STORM SEWER IMPROVEMENTS

B&B Air Parts

CITY OF WICHITA, KANSAS

AS BUILTS

B&B Air Parts SWS Plan and Profile - Line 1 Wichita, Kansas

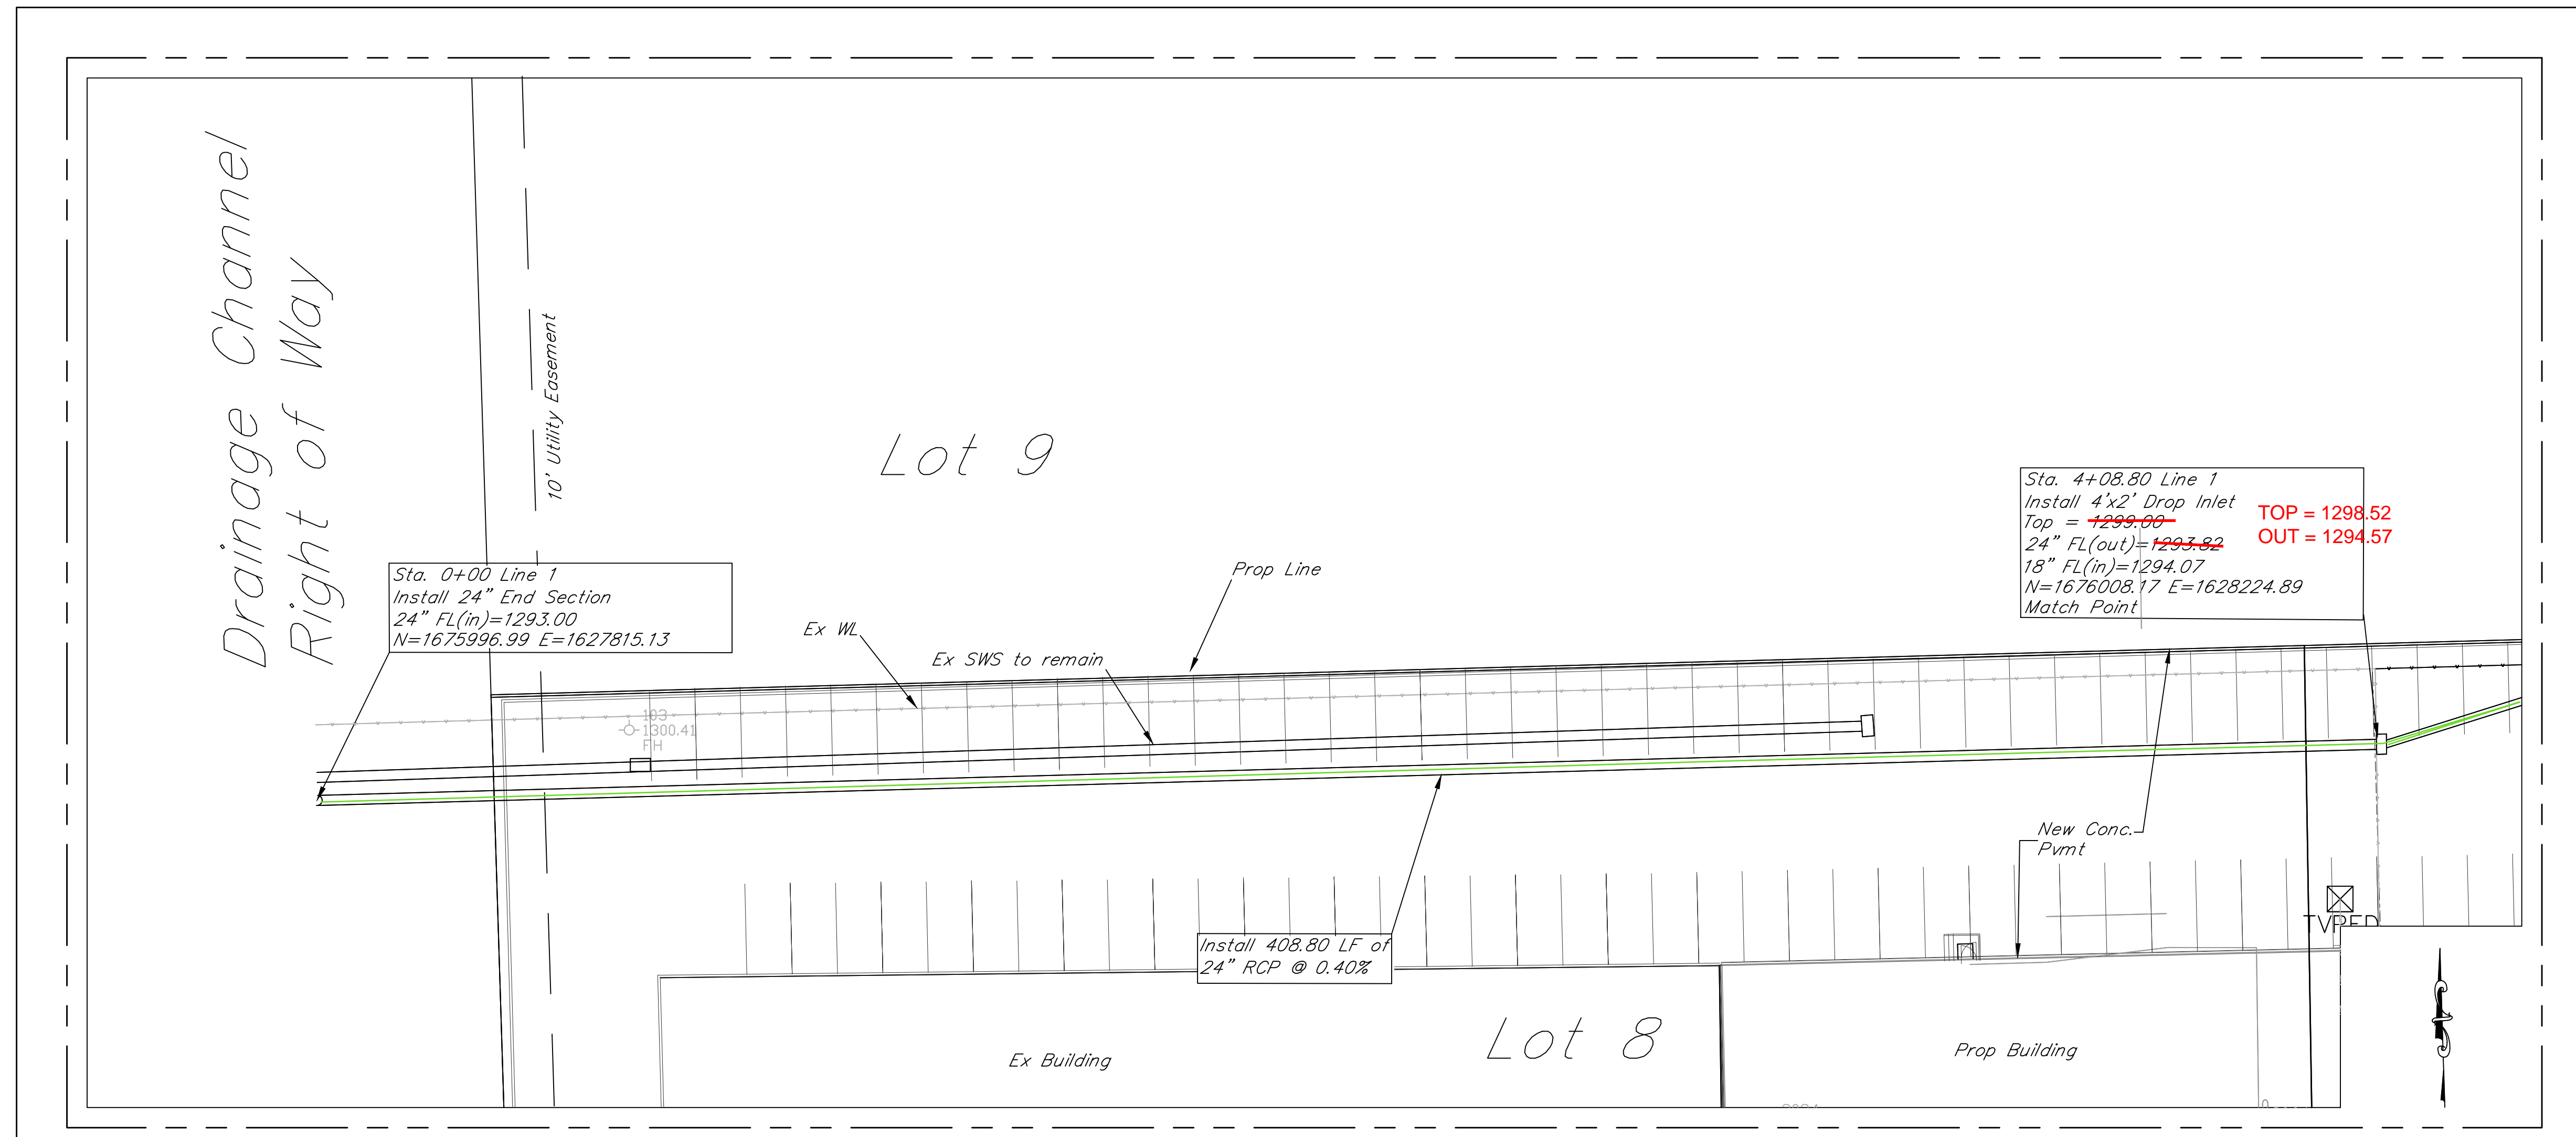
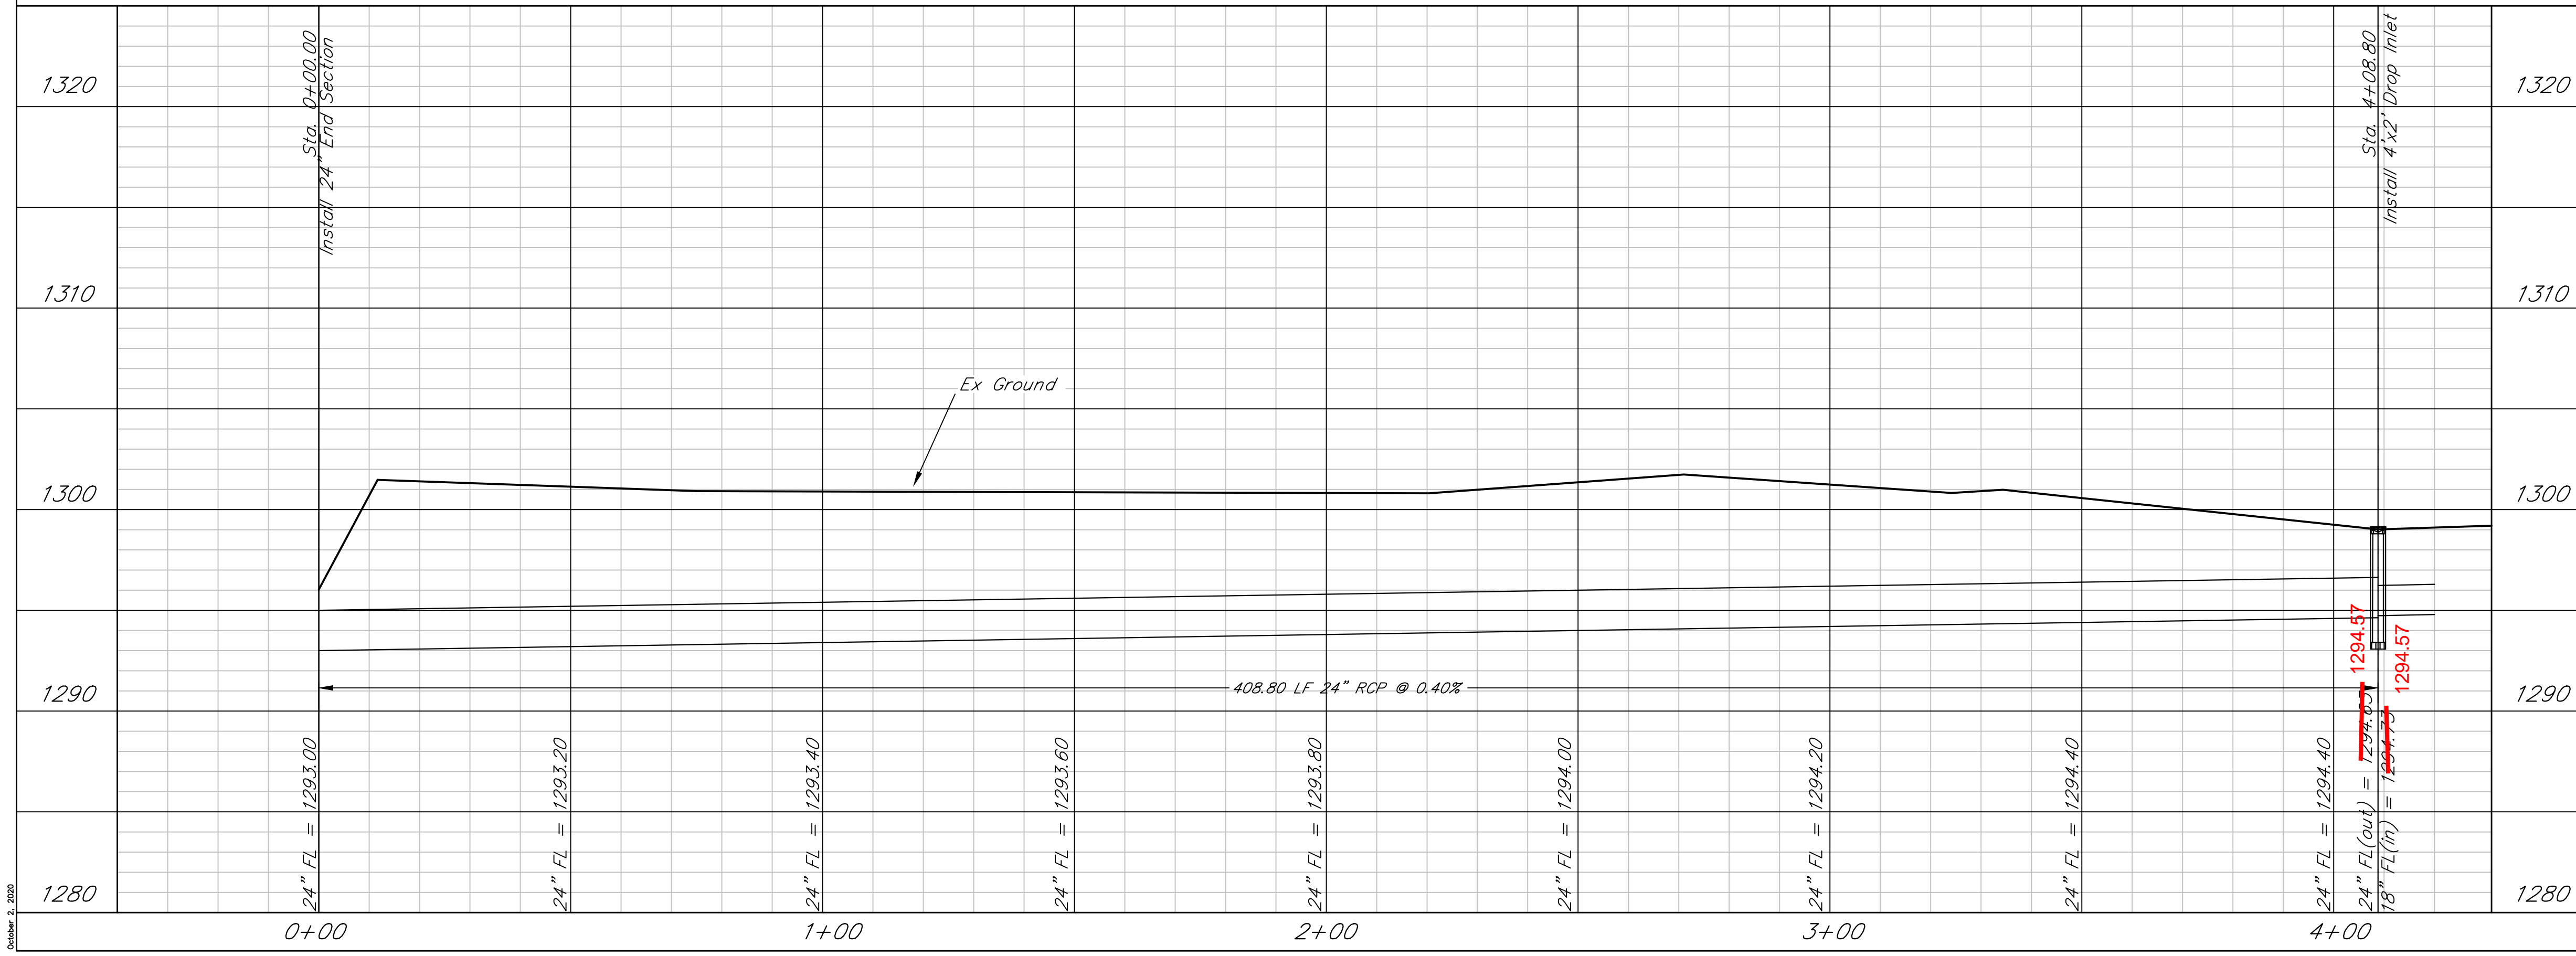
Sta. 4+08.80 Line 1
 Install 4"x2" Drop Inlet
 Top = ~~1299.60~~ TOP = 1298.52
 24" FL(out) = ~~1293.82~~ OUT = 1294.57
 18" FL(in) = 1294.07
 N=1676008.17 E=1628224.89
 Match Point

B&B Air Parts
SWS Plan and Profile - Line 2
 Wichita, Kansas

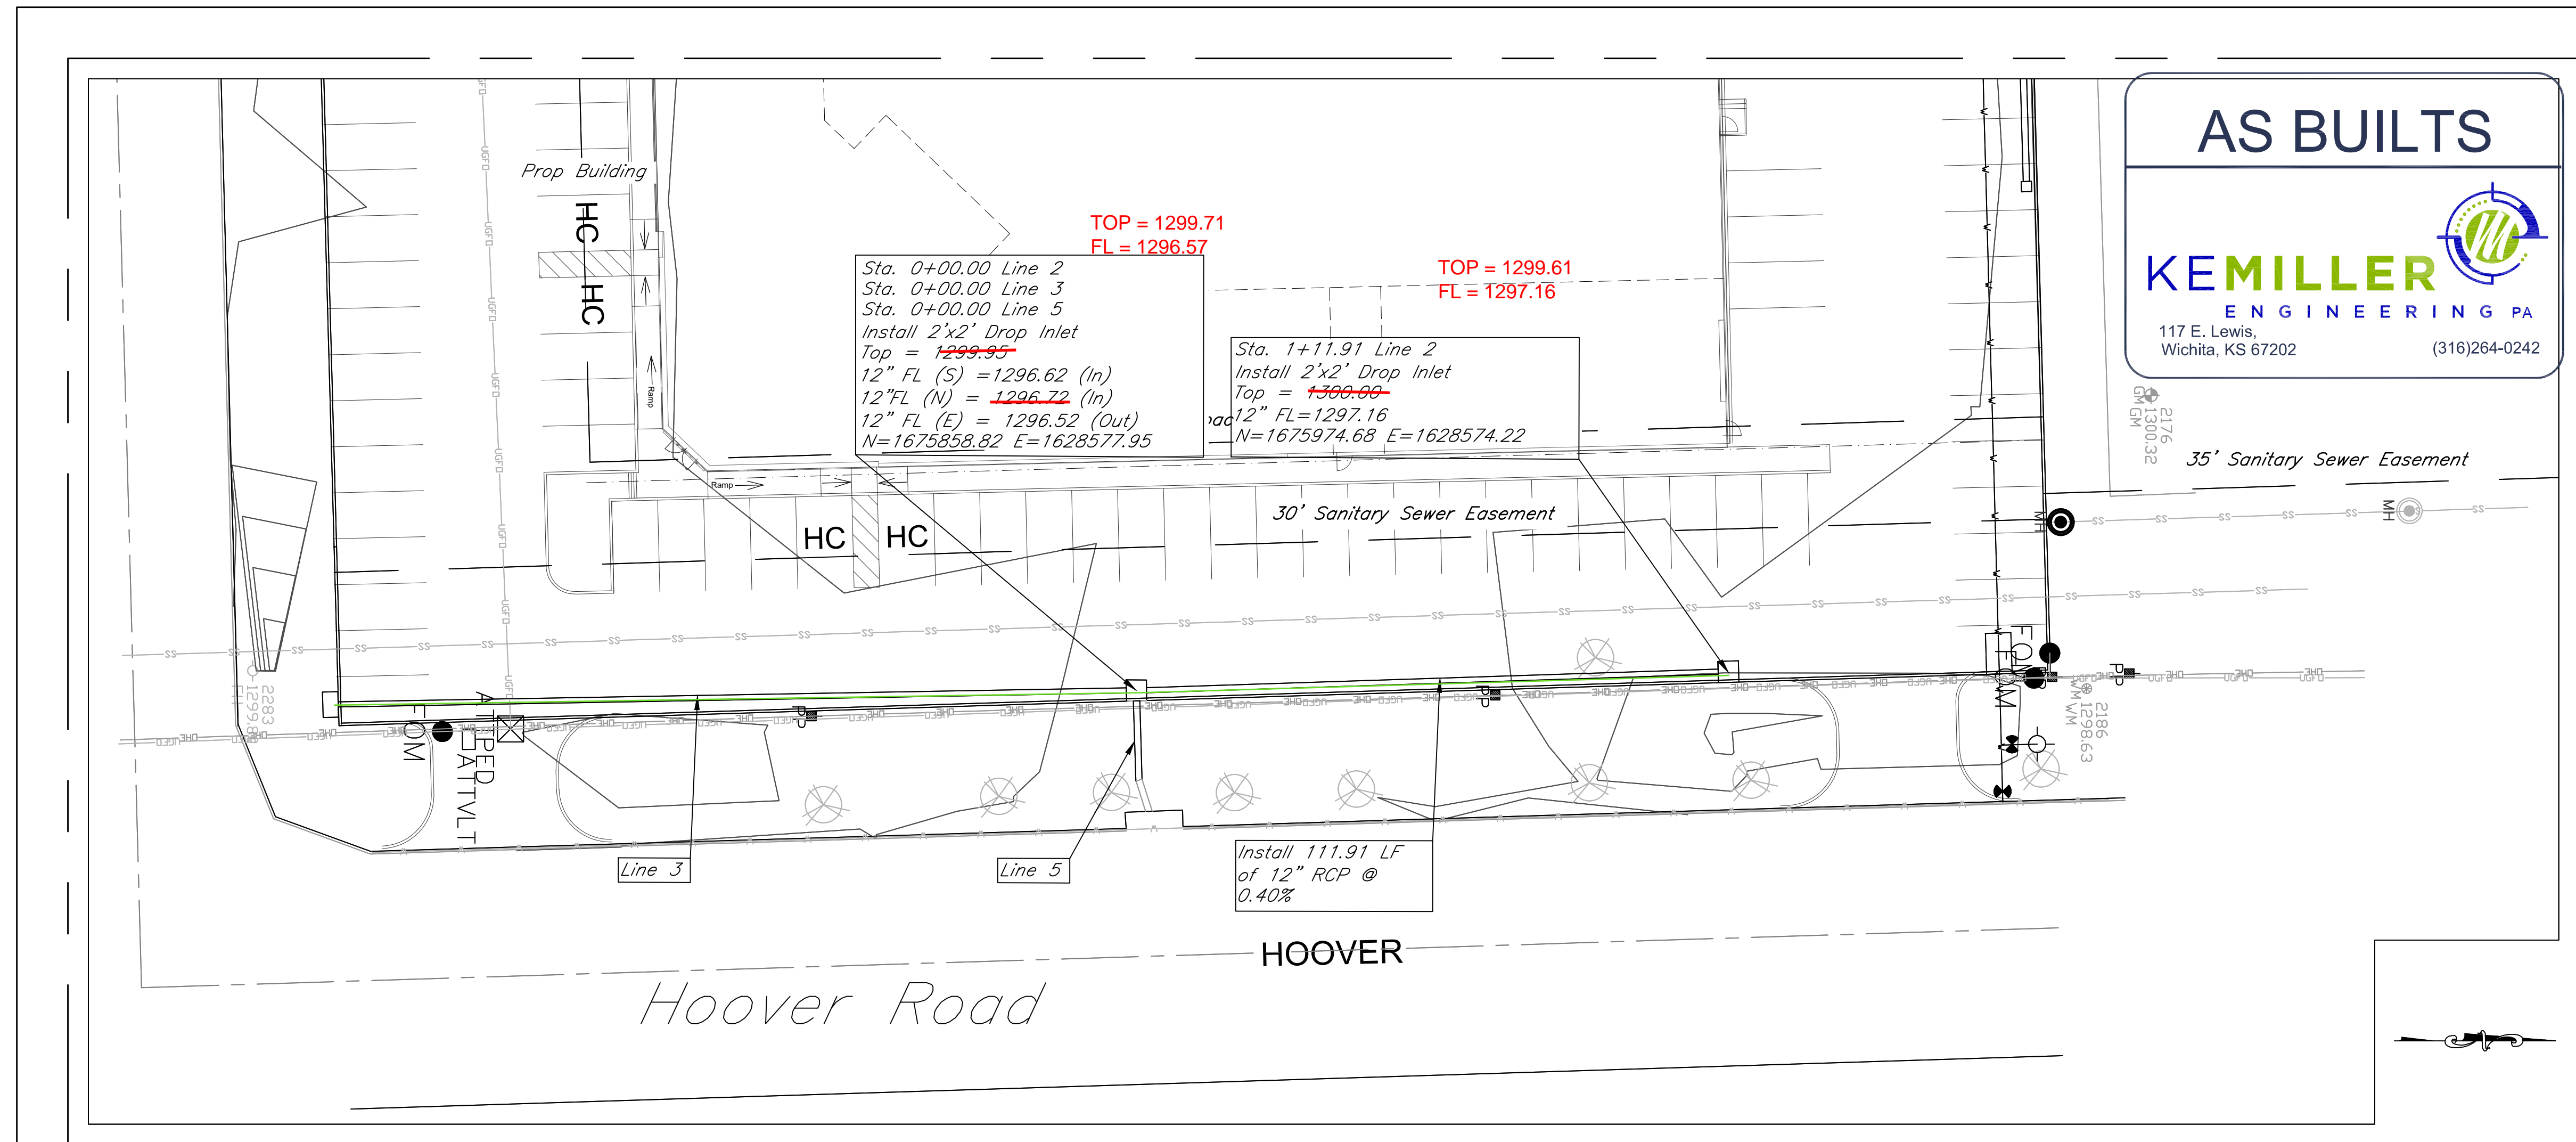
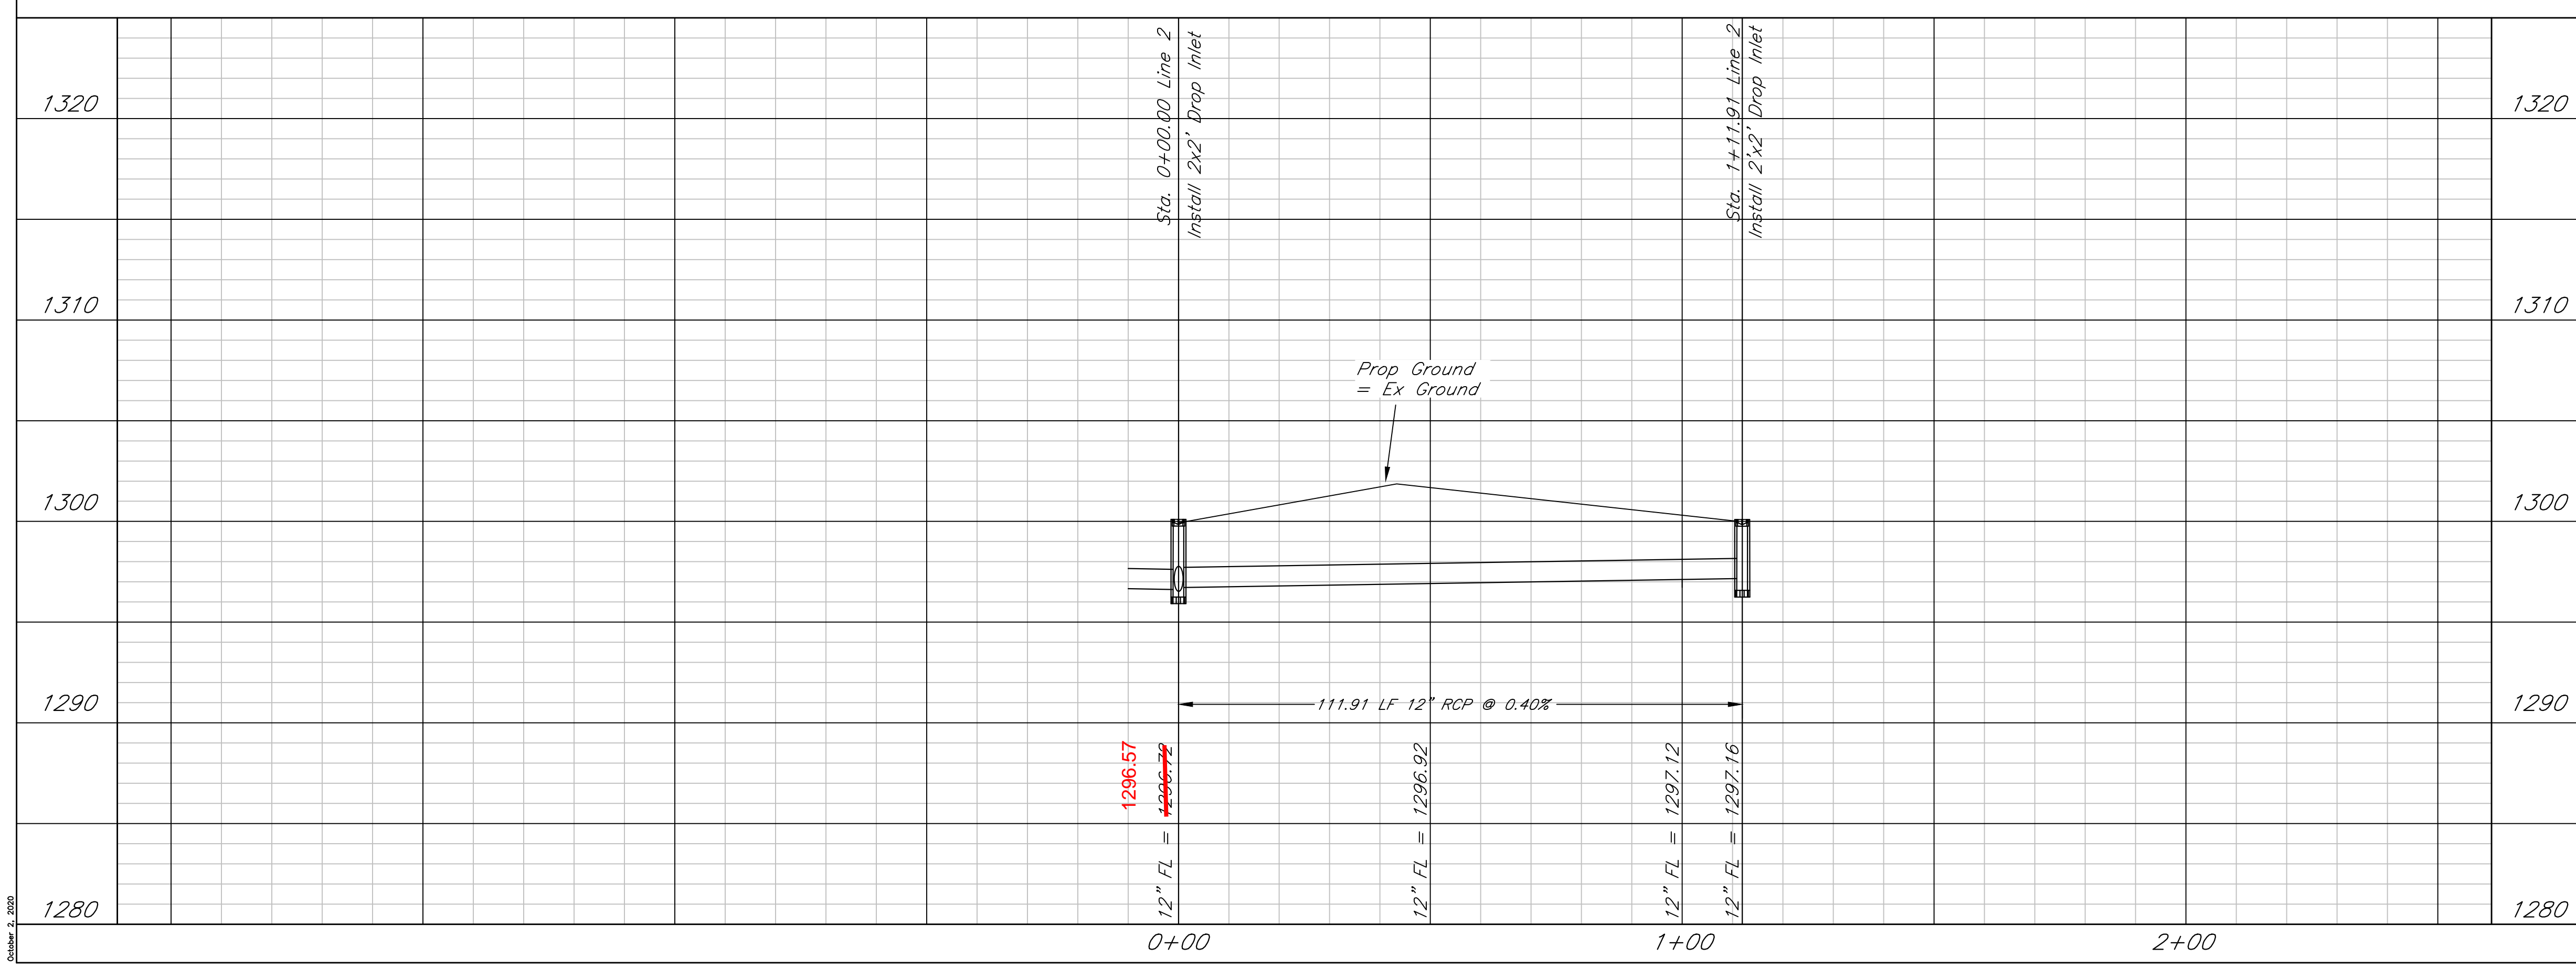
Sta. 0+00.00 Line 2
 Sta. 0+00.00 Line 3
 Sta. 0+00.00 Line 5
 Install 2'x2' Drop Inlet
 Top = ~~1299.95~~
 12" FL (S) = 1296.62 (In)
 12" FL (N) = ~~1296.72~~ (In)
 12" FL (E) = 1296.52 (Out)
 N=1675858.82 E=1628577.95

Sta. 1+11.91 Line 2
 Install 2'x2' Drop Inlet
 Top = ~~1300.00~~
 12" FL = 1297.16
 N=1675974.68 E=1628574.22
